Re: 2017/6907/P 13a Pond Street NW3

13a Pond Street, application no. 2017/6907/P

Objections to Planning Proposal for 13A Pond Street 2017/6907/P

Diagram of local groundwater flow by Dr Michael de Freitas, Emeritus Reader of Engineering Geology Imperial College, London

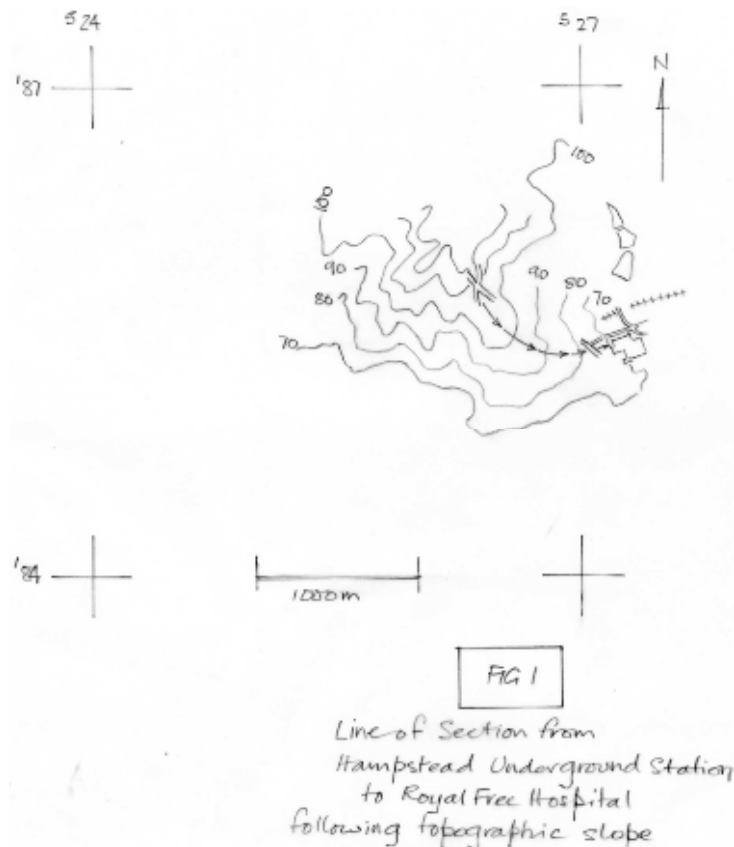
1) The hydrogeologists employed for this site have been inaccurate in describing the ground here as being of very low permeability when this could be far from the case; their own data refutes this! Firstly they have failed to dig a borehole in the most likely place for the east-flowing groundwater here to be found and to have an influence on the trees, particularly if constrained by a basement in its path. Borehole 2 should have been dug further west near the boundary to catch the groundwater flowing past the house here.
